TechInfo Sheet

Model: SE-CH570

Subject: Fan Motor Failure

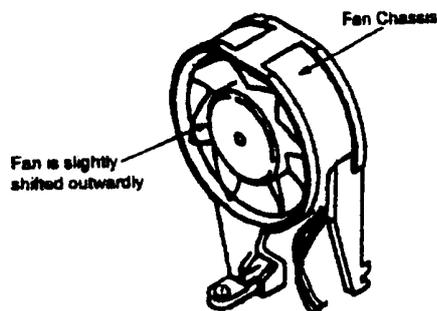
SYMPTOM: Power supply turns off during operation. 'F61' is displayed on the FL.
(Occurs at a level of sound volume where the fan rotates).

CAUSE: The motor fan dislocated either by a fall during transportation or by vibration, fails to rotate. Upon failure of the fan, the protector circuit turns off power supply and, at the same time, indicates 'F61' on the FL.

REMEDY: The motor fan fixing ribs are changed in shape so that the fan will not be dislocated easily.

- When the fan is found dislocated, insert it. If the inserted fan works properly, it can be used as it is. (No dislocation unless the set is dropped by mistake.)
- The fan motor of which the fan come easily out after re-insertion should be replaced with new one.
